ADDENDUM TO THE TECHNICAL DRAINAGE STUDY FOR RANCHO MULTI FAMILY

PROJECT 4555.007

CITY OF LAS VEGAS INTER-OFFICE MEMORANDUM			DATE: November 25, 2020
TO: Land Development Services Department of Building & Safety			FROM: Jennifer Shinn, P.E. Flood Control, Engr. Associate Department of Public Works
SUBJECT:	Drainage Study for:		COPIES TO:
	Rancho Multi Family		RCI Engineering
Cross Streets:	Decatur Boulevard and Airport Drive		Edward Homes
File Number:	F:\Depot\DSMemos\DS5380A.doc		Bart Anderson, P.E., DevCo
Parcel Number:	139-18-410-012		CCRFCD
Zoning Action:			NDOT
FEMA Flood Zone	YES	NO X	
Proposed Storm Drain	YES X	NO

RE: Rancho Multi Family
DS5380A

FIGURE 5_REV

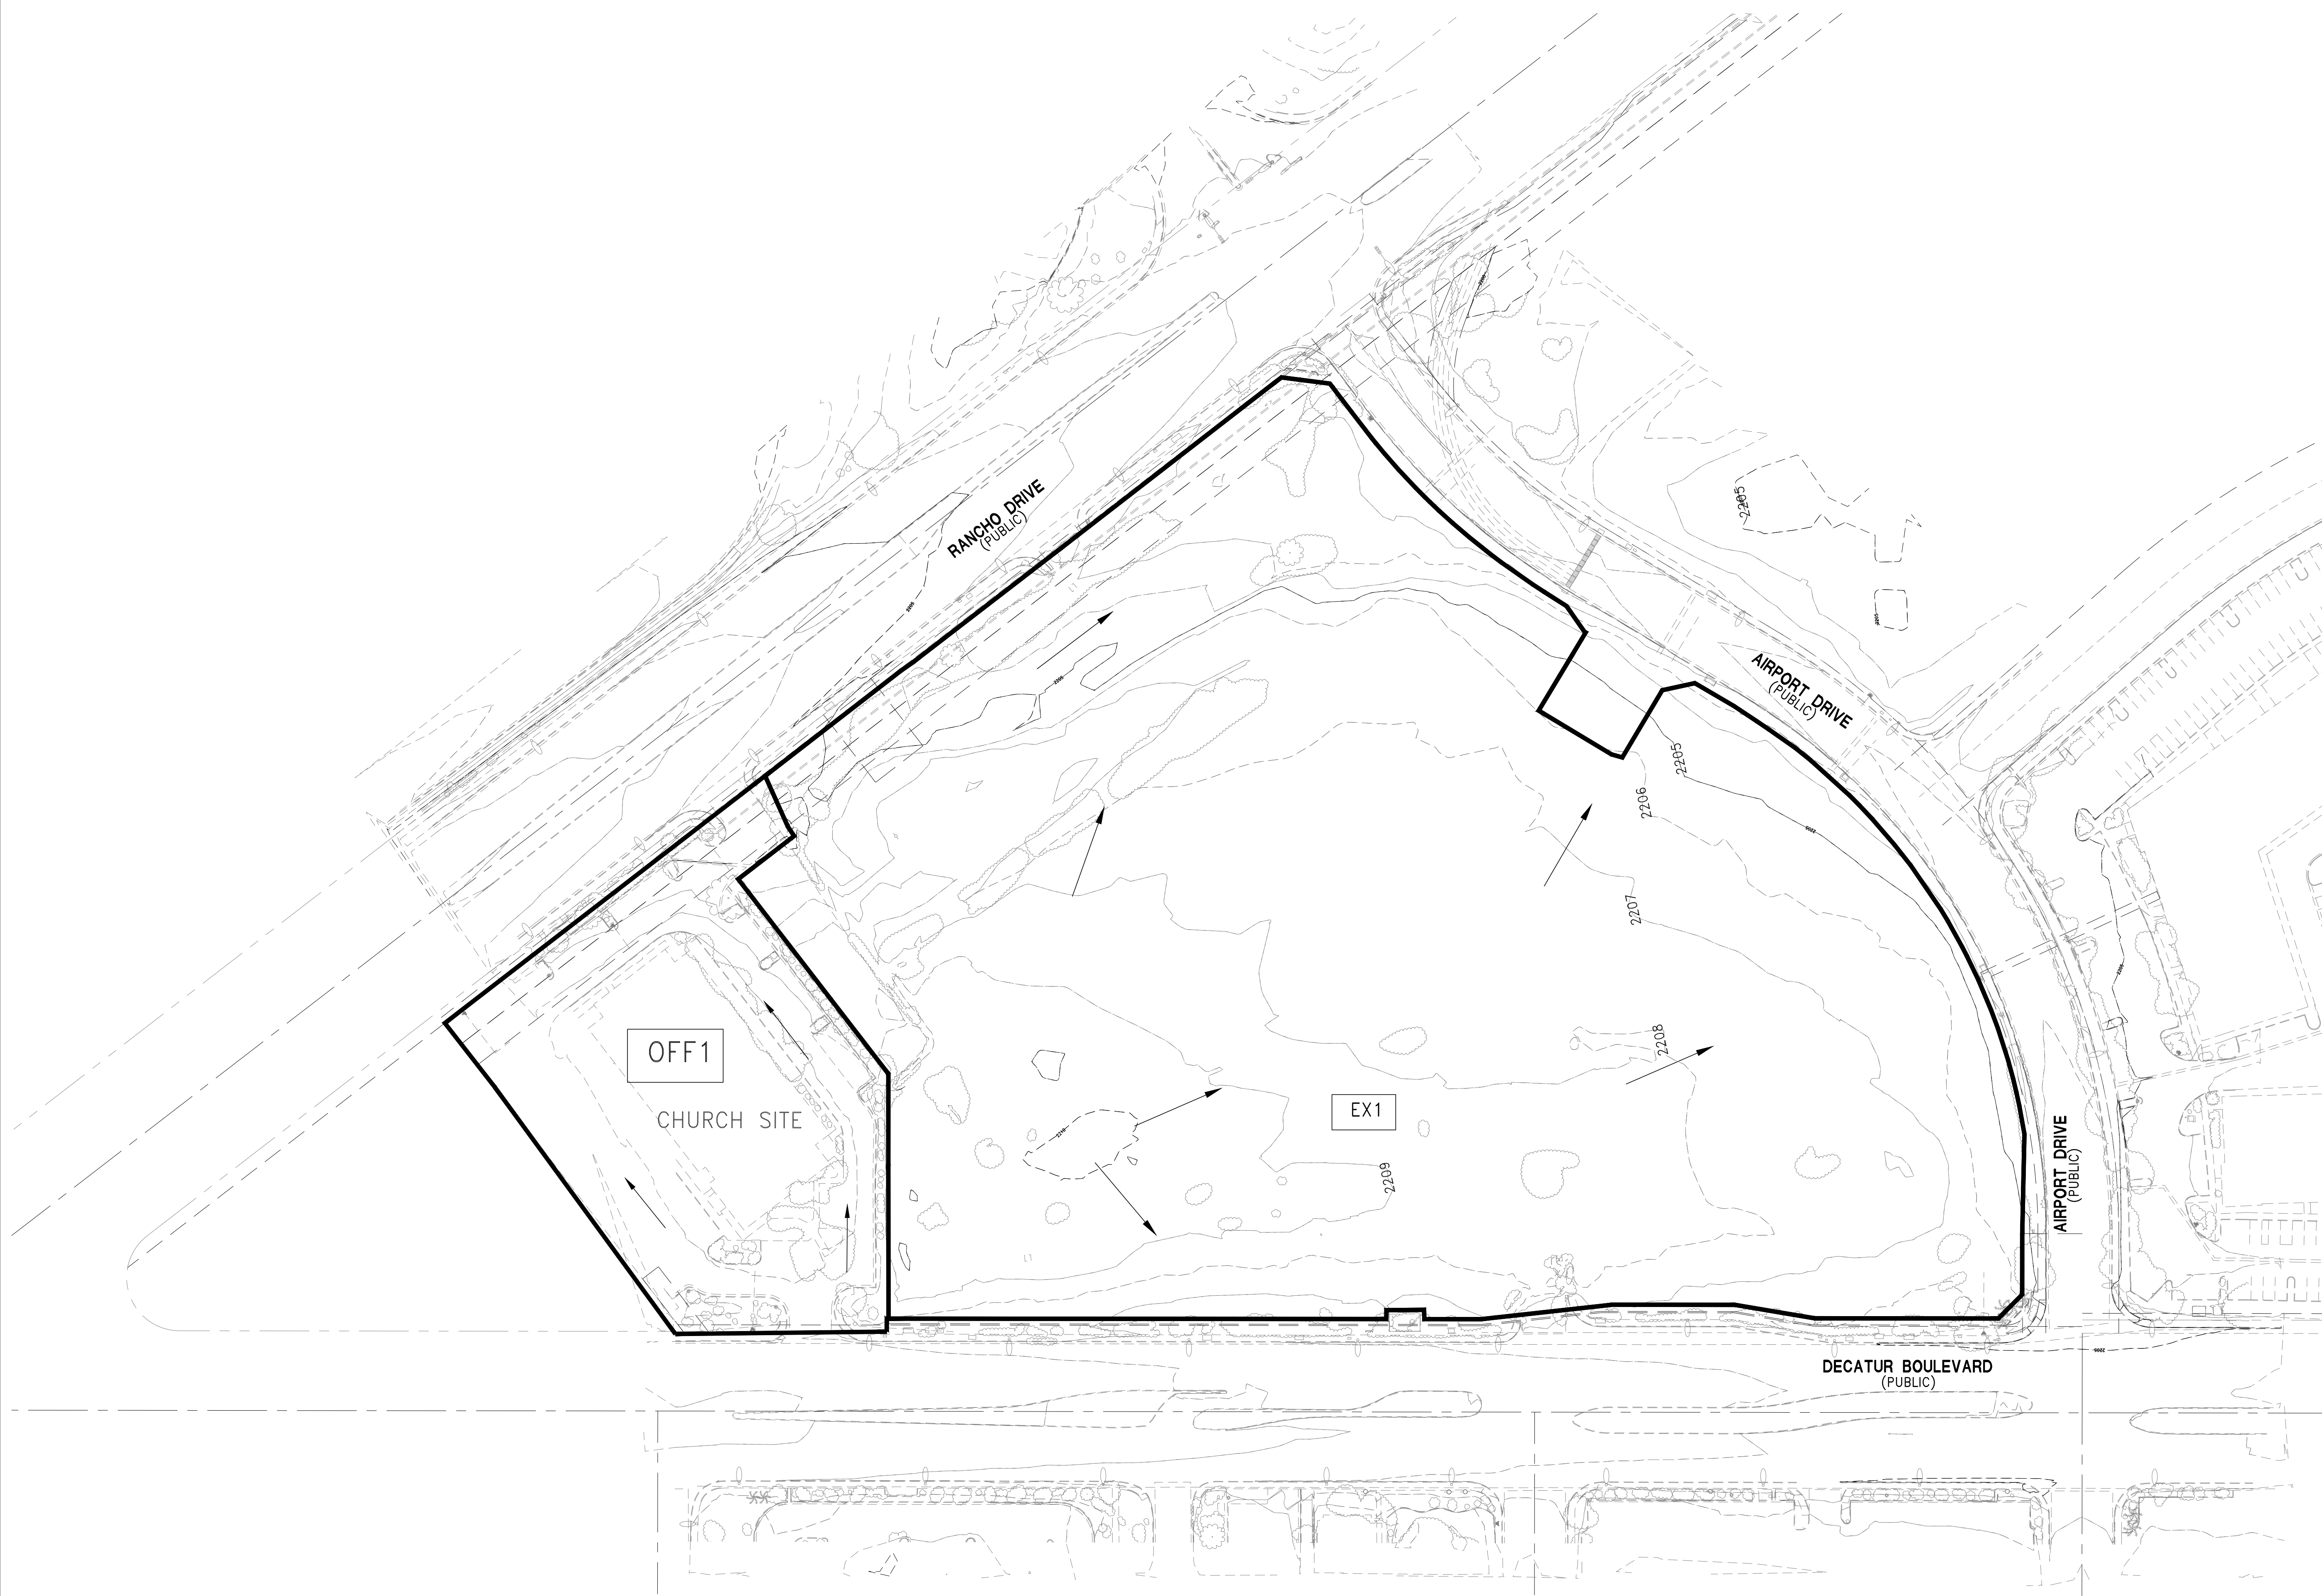
18. **Figure 6:** The prorated basin flows of ON1 for the proposed condition sum to be 27 cfs, however ON1 has 28 cfs. Address the discrepancy.
19. **Figure 5:** Include OFF1 in the existing condition exhibit and analysis.

Comment 19: Figure 5: Include OFF1 in the existing condition exhibit and analysis.

Response: OFF 1 has been added to Figure 2 and an updated HEC model including OFF1 has been included with this addendum.

FIGURE 6_REV

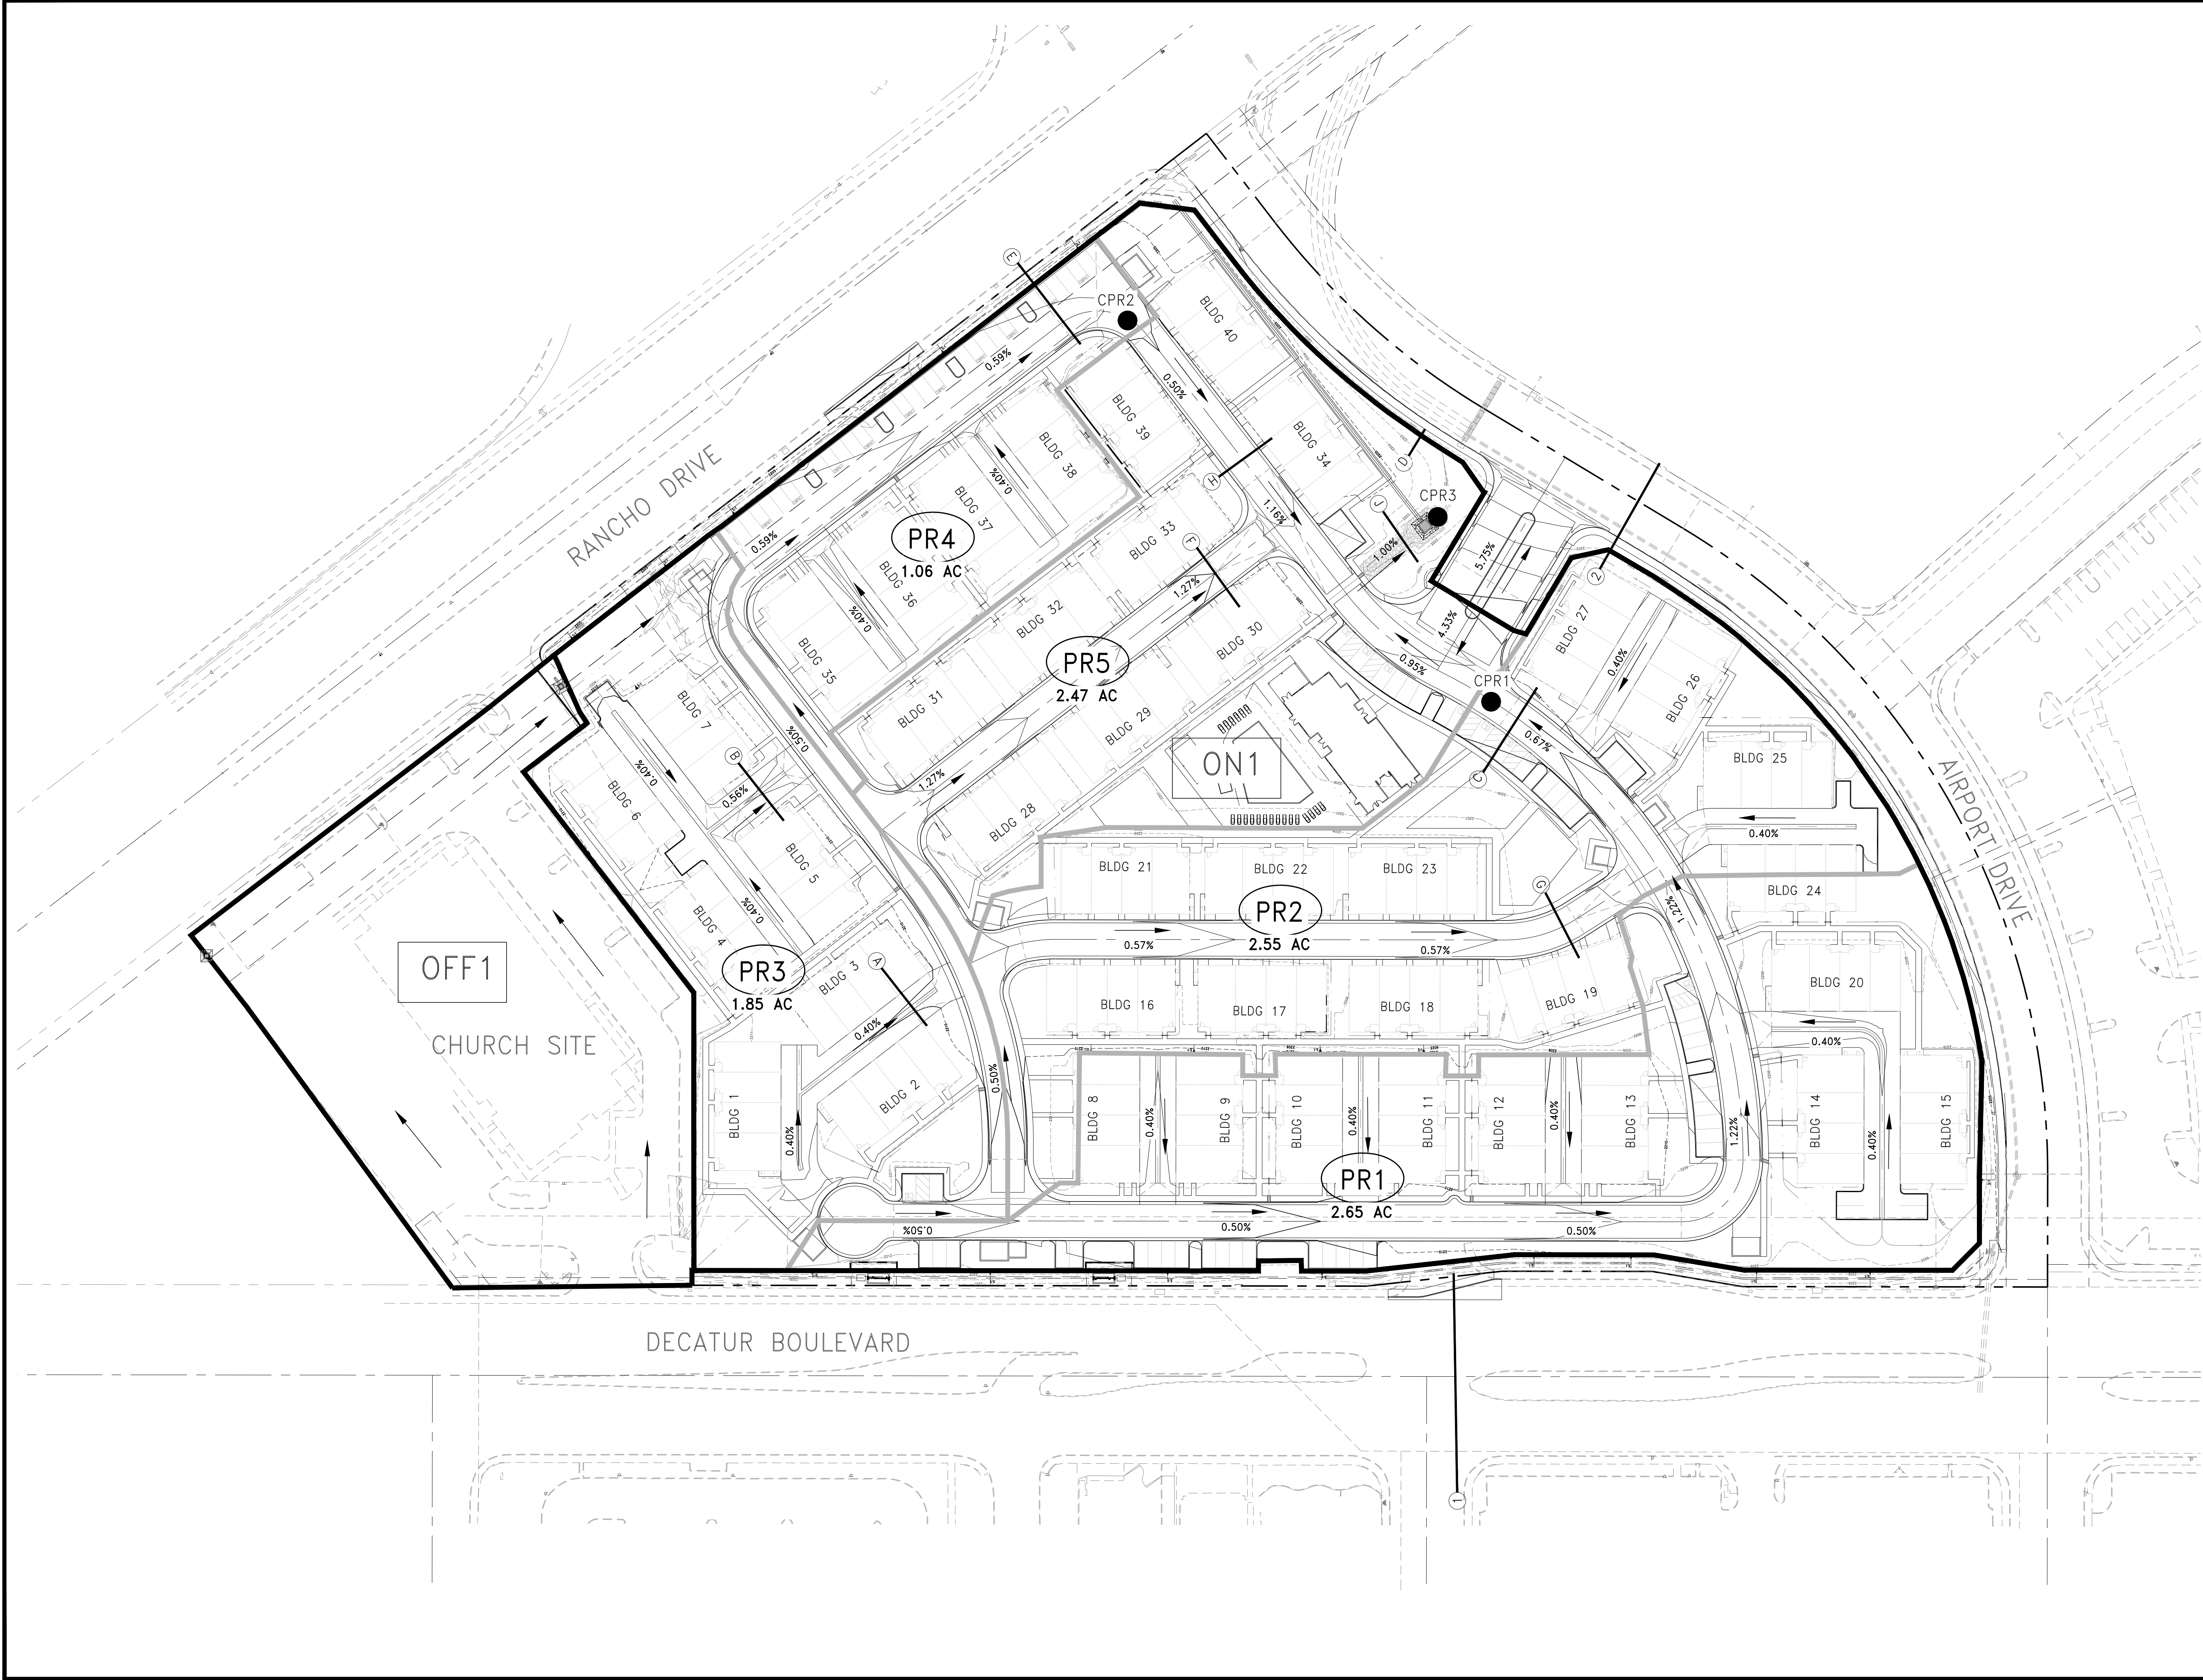
16. **Figure 6:** The prorated basin areas of ON1 for the proposed condition sum to be 9.15 acres, however ON1 is 10.58 acres. Address the discrepancy.

17. **Figure 6:** PR5 is shown to have 2.5 cfs/acre, while all other prorated basins are shown to have 2.65 cfs/acre. It is also listed to have the same acreage in the table, but it shown to have 2.5 acres on the exhibit. Address these discrepancies.

21. Velocity for Street section 2 is shown as 5.5 fps on the provided Flow Master Report, but is shown and 5.2 fps on Figure 6.
22. The common areas as well as the private streets are all to be designated a Public Drainage Easements to be privately maintained by the HOA. In the next submittal, provide an overall lot drainage map to identify intra-lot drainage areas which will be required as common lot as well as public drainage easements to be privately maintained by the Homeowners Association.

Comment 16: Figure 6: The prorated basin areas of ON1 for the proposed condition sum to be 9.15 acres, however ON1 is 10.58 acres. Address the discrepancy.

Comment 17: Figure 6: PR5 is shown to have 2.5 cfs/acre, while all other prorated basins are shown to have 2.65 cfs/acre. It is also listed to have the same acreage in the table, but it shown to have 2.5 acres on the exhibit. Address these discrepancies.

Comment 18: Figure 6: The prorated basin flows of ON1 for the proposed condition sum to be 27 cfs, however ON1 has 28 cfs. Address the discrepancy.

Comment 21: Velocity for Street section 2 is shown as 5.5 fps on the provided Flow Master Report, but is shown and 5.2 fps on Figure 6.

Response: Figure 6 has been revised to reflect the correct area for each basin and now matches the total area of Basin ON1.

Response: This typo has been corrected and all flows are based upon the prorated flow of 2.65 cfs/acre.

Response: Areas a prorated flows have been revised per comments 16 and 17 and flows have been taken to the tenth (0.1) of a cfs and not total 28 cfs which matches the ON1 flow.

Response: Figure 6 has been revised to reflect the correct velocity of 5.5 fps.
